**Response to the “Notice of Disapproval for the
Investigation Work Plan for Upper Sandia Canyon Aggregate Area,
Los Alamos National Laboratory EPA ID No: NM0890010515, HWB-LANL-08-010,”
Dated June 25, 2008**

To facilitate review of this response, the New Mexico Environment Department’s (NMED’s) comments are included verbatim. The comments are divided into general and specific categories, as presented in the notice of disapproval. Los Alamos National Laboratory’s (LANL’s or the Laboratory’s) responses follow each NMED comment. This response contains data on radioactive materials, including source, special nuclear, and byproduct material. Information on radioactive materials and radionuclides, including the results of sampling and analysis of radioactive constituents, is voluntarily provided to NMED in accordance with U.S. Department of Energy (DOE) policy.

Photographs and Schematic Diagram of the Asphalt Batch Plant

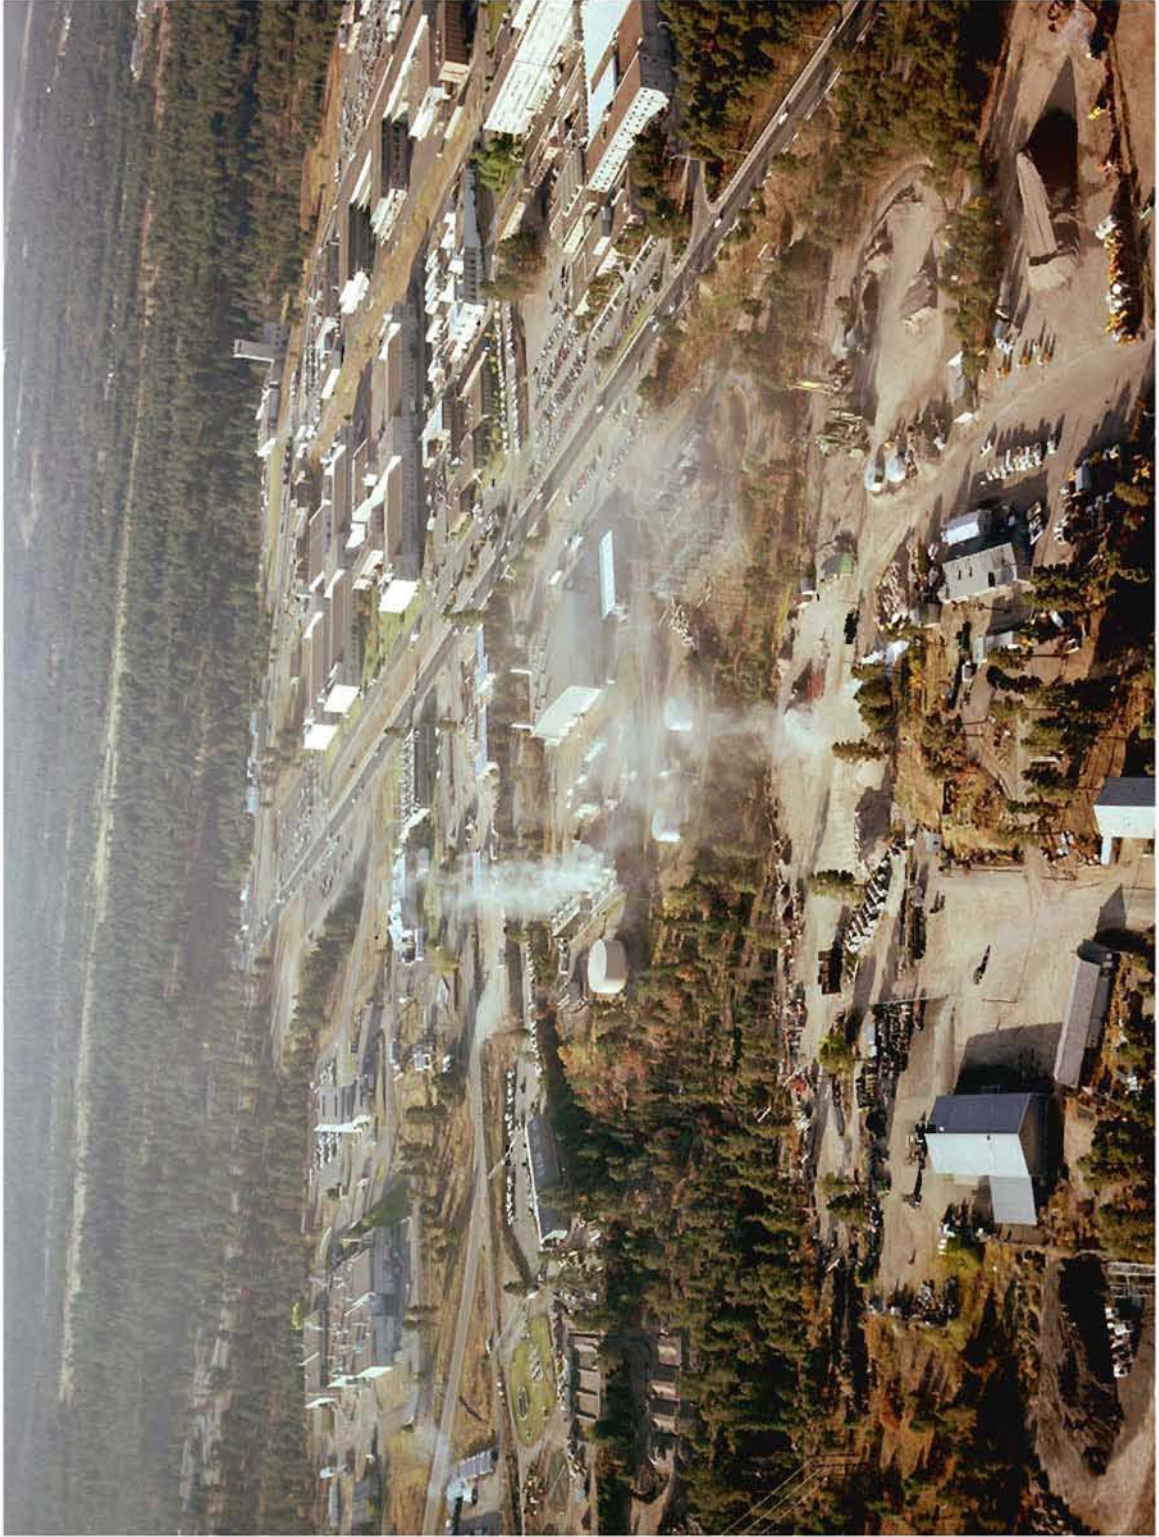
According to Figure 4.1-2, sampling location 03-22528 is associated with SWMU 03-028, and sampling location 03-22537 is associated with SWMU 03-009(a). However, Table 4.1-1 reports these two locations as associated with AOC 03-043(b). No samples appear to be collected at AOC 03-043(b) according to Figure 4.1-2. Resolve the discrepancy and revise the associated text and tables. The Permittees must collect samples underneath the former aboveground tank to define the nature and extent of contamination. Stained soil was observed under the tank during excavation of the tank. Although the soil beneath the tank was removed, no confirmatory samples were collected.

The Permittees must provide documentation to support the assertion that the SWMUs 03-043(f) & 03-043(g) are duplicates of SWMUs 03-036(c) & 03-036(d), respectively.

AOC 03-043(b), the former asphalt emulsion storage tank (structure 03-0077), was located next to the AOC 03-043(d) asphalt storage tank (structure 03-0076) (see Attachment 1). Because of the close proximity of these two tanks, they would have shared a common area of potential contamination. As discussed in LANL's response to NMED Comment 8, AOC 03-043(d) is same area of potential soil contamination as SWMU 03-036(a). Because AOC 03-043(b), the asphalt emulsion storage tank (structure 03-0077), was located next to the AOC 03-043(d) asphalt storage tank (03-0076), it too would have the same area of potential soil contamination as SWMU 03-036(a).

LANL has revised the text of sections 4.1.27 and 4.1.28 to include this information. In addition, a Polaroid photograph of the two northern emulsion storage tanks, a utility schematic of the asphalt batch plant, and a 1993 aerial photograph of the asphalt batch plant are included in Attachment 1. Copies of the relevant pages of the 1990 SWMU report are included in Attachment 2.
